Hornsea Project Three
Offshore Wind Farm

Appendix 30 to Deadline I – Permanent Access Note for Onshore HVAC Booster Station

**HORNSEA 3 OFF-SHORE WIND FARM
SAXTHORPE, NORFOLK: BOOSTER STATION
HIGHWAY ACCESS WORKS**

STAGE 1 ROAD SAFETY AUDIT

4. Designer Response to Road Safety Audit

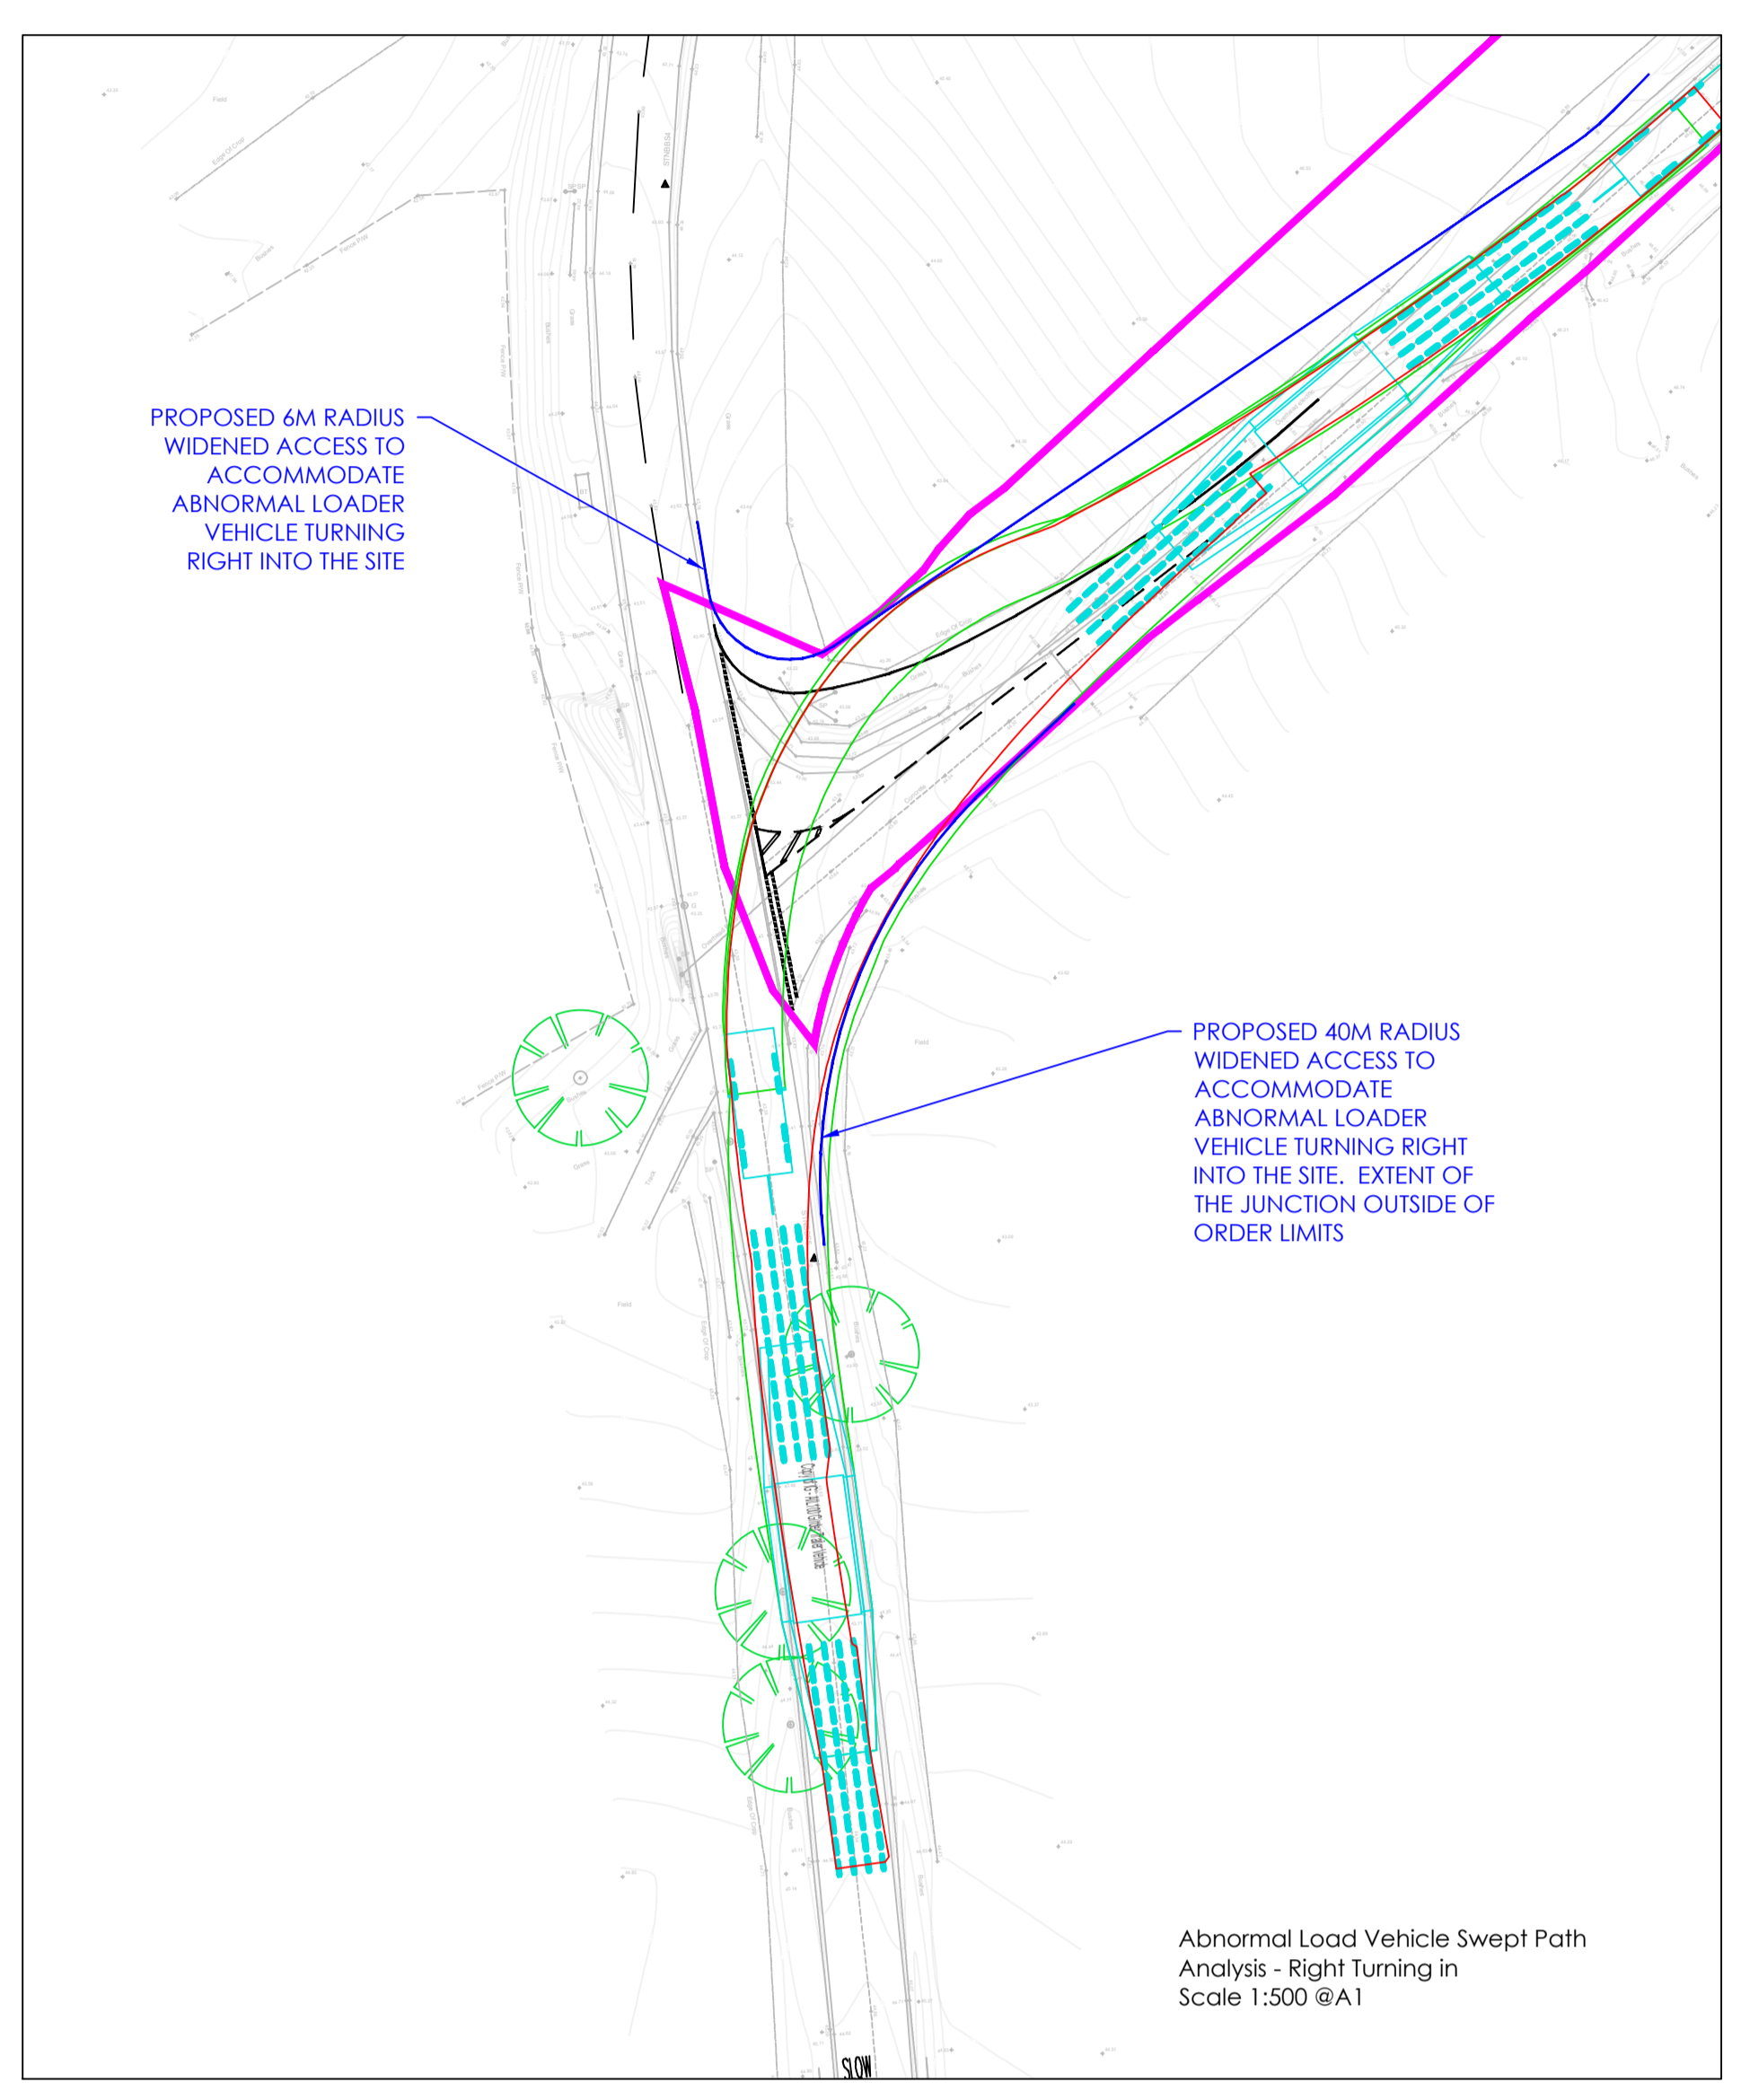
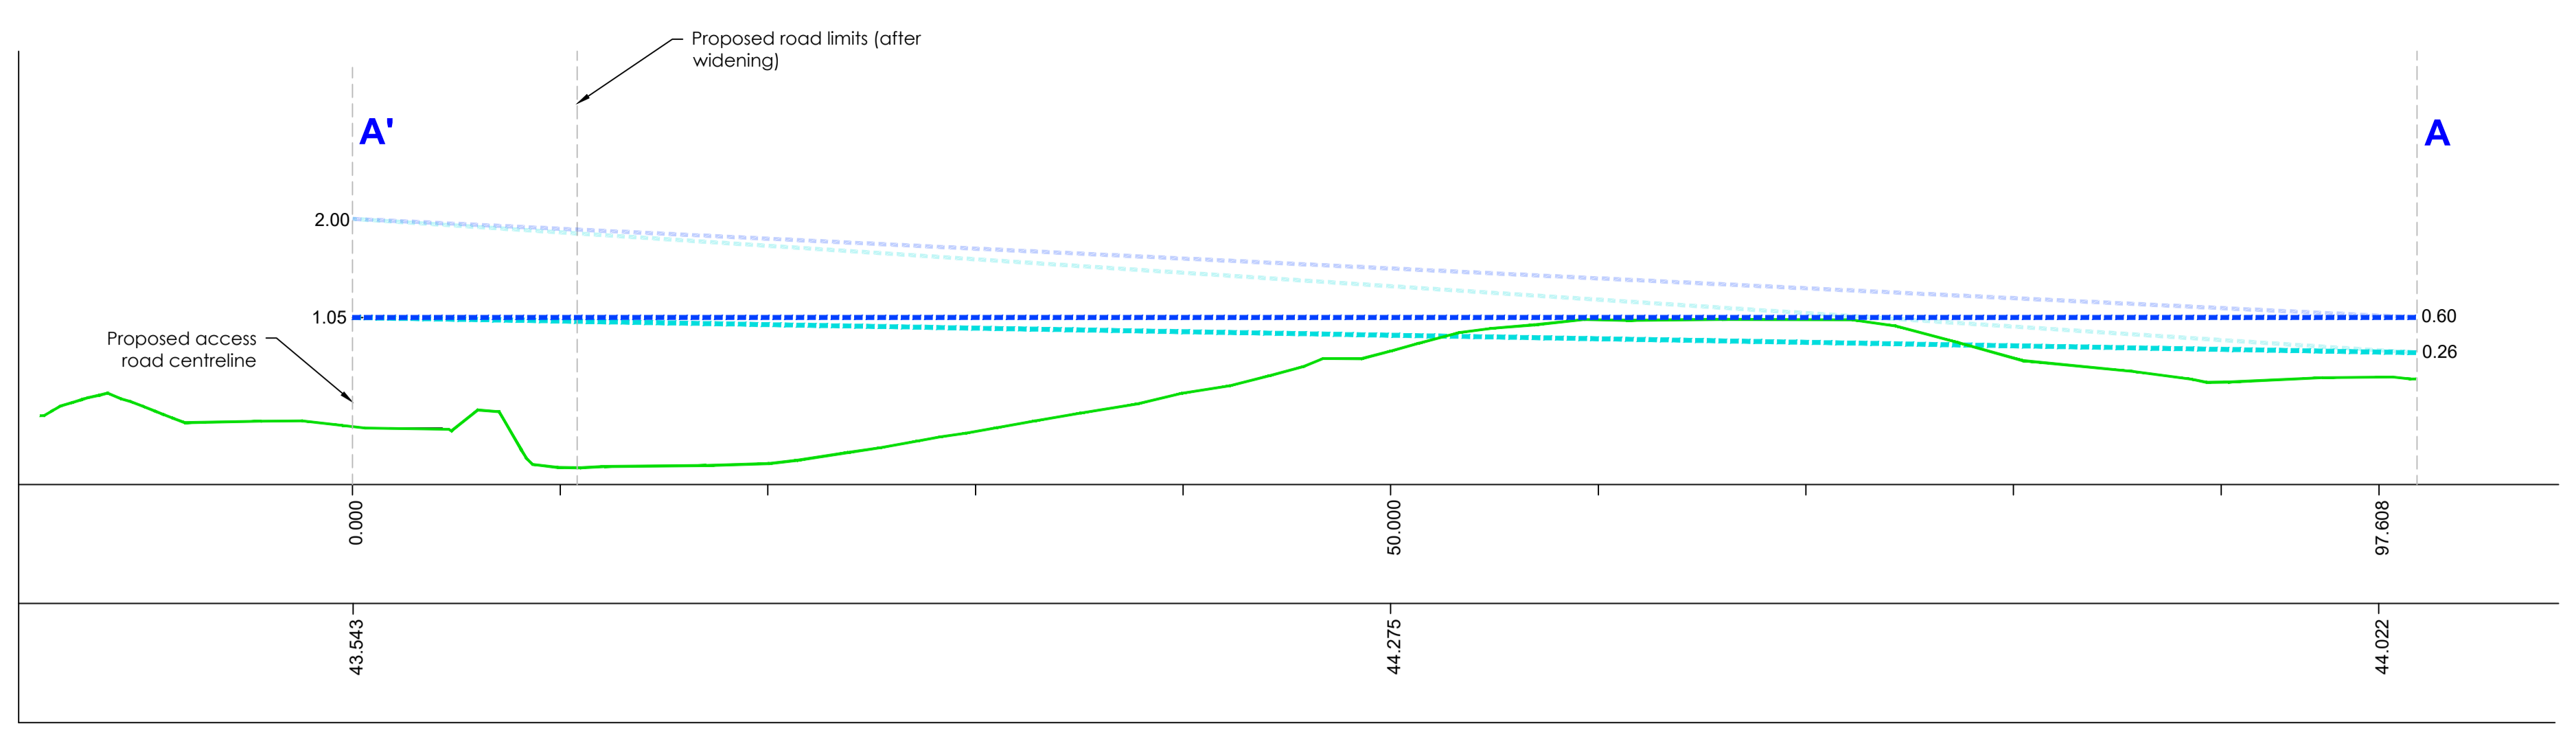
- 4.3 In addition to the above a series of minor alterations have been made to the drawing in response to comments from Norfolk County Council and to reflect property ownership boundaries.
- 4.4 The changes made are shown on Create drawing number 03 / 202 Rev A in Appendix A and include the following;
- Temporary overrun area include which is to be removed post construction, coloured in yellow on the plan;
 - Junction vertical visibility changed in discussion with Norfolk County Council to accommodate a vertical visibility splay of 1.05m to 0.26m; and
 - Temporary overrun area relocated to the north of the current farm track.

APPENDIX B – Problem Location Plan

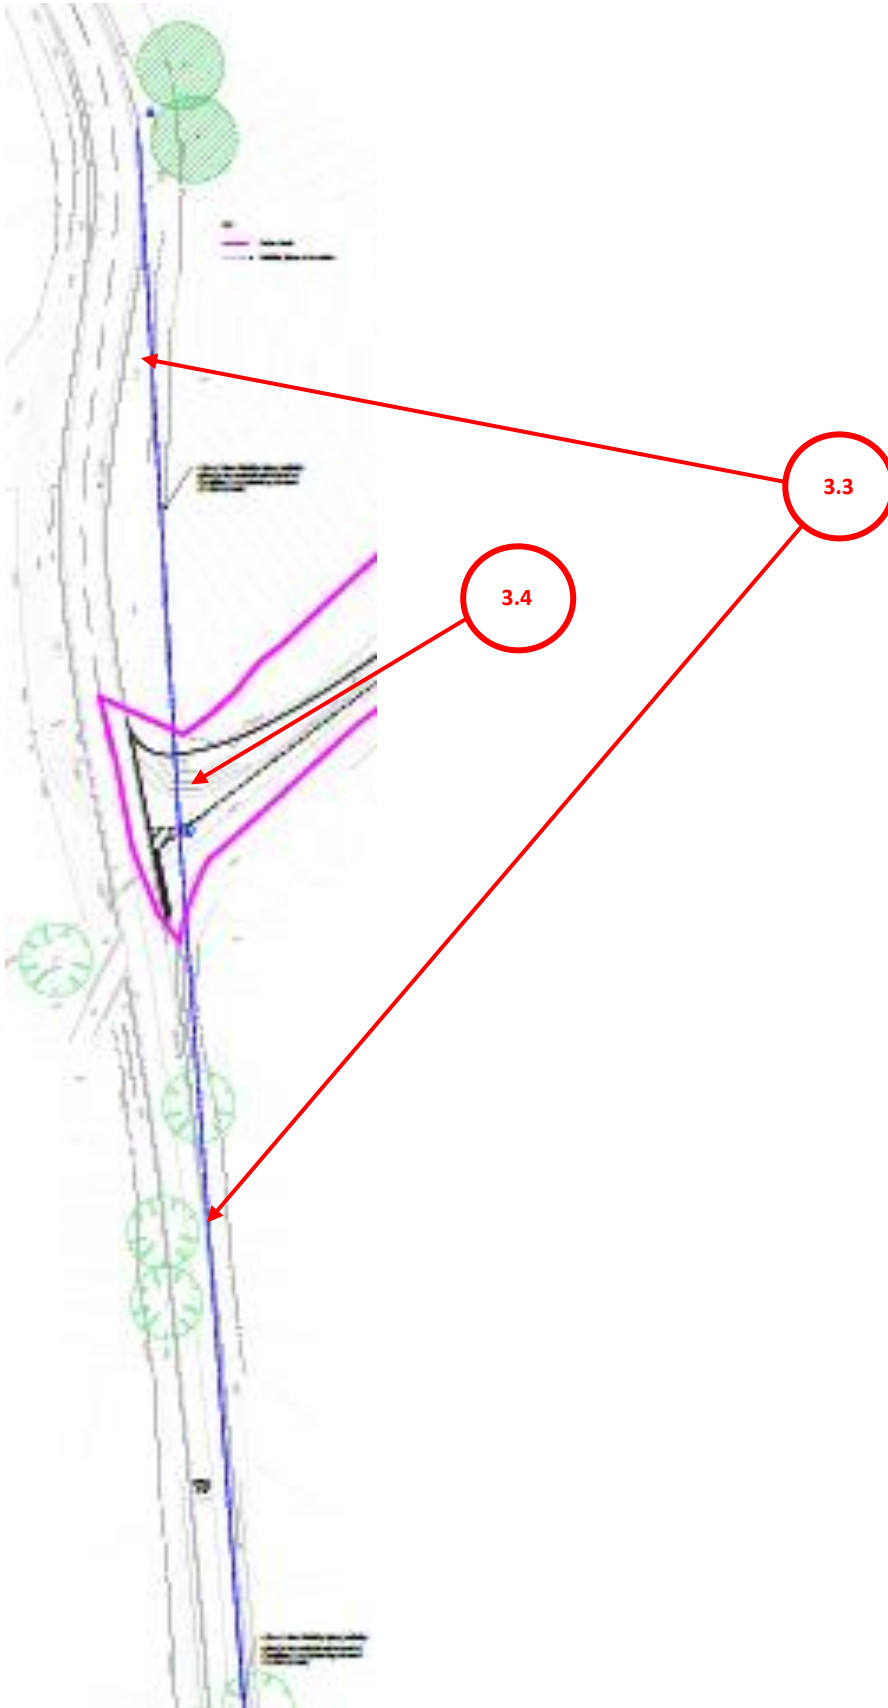
Junction visibility splays on the drawing indicate 160m to the south and 100m to the north (although 120m appears to be available). These equate to design speeds of 85kph and 70kph respectively; however no speed measurement data was submitted to support this. Timings taken on site by the Auditors indicate that cars were visible on each approach for 8 to 10 seconds, suggesting that traffic speeds lie within these design speeds. This issue is not therefore raised as a safety problem, nevertheless the local highway authority may require speed data to support the proposals.

Furthermore, part of the visibility envelope to the north appears to lie over uncultivated private land (although the precise highway boundary is difficult to identify). Due to the ground profile, regular maintenance of this verge will be necessary to sustain visibility, and formal arrangements with the landowner may be required.

The drawing provided for audit does not give any detail of the proposed form of construction - kerbing, pavement, drainage etc. This could have a bearing on safe operation of the junction, particularly the avoidance of ponding/detritus on the highway. The latter is of particular importance as the access road is on a down gradient towards the junction. Early consideration is advised.

4.11 A speed data survey is to be provided to the Highway Authority prior commencement of any access works, in order to demonstrate that traffic speeds lie within design speeds of the road.

4.13 An updated plan containing the proposed construction of the junction or temporary left turn overrun area; including kerbing, pavement material and drainage would be submitted prior to commencement of any work for approval.
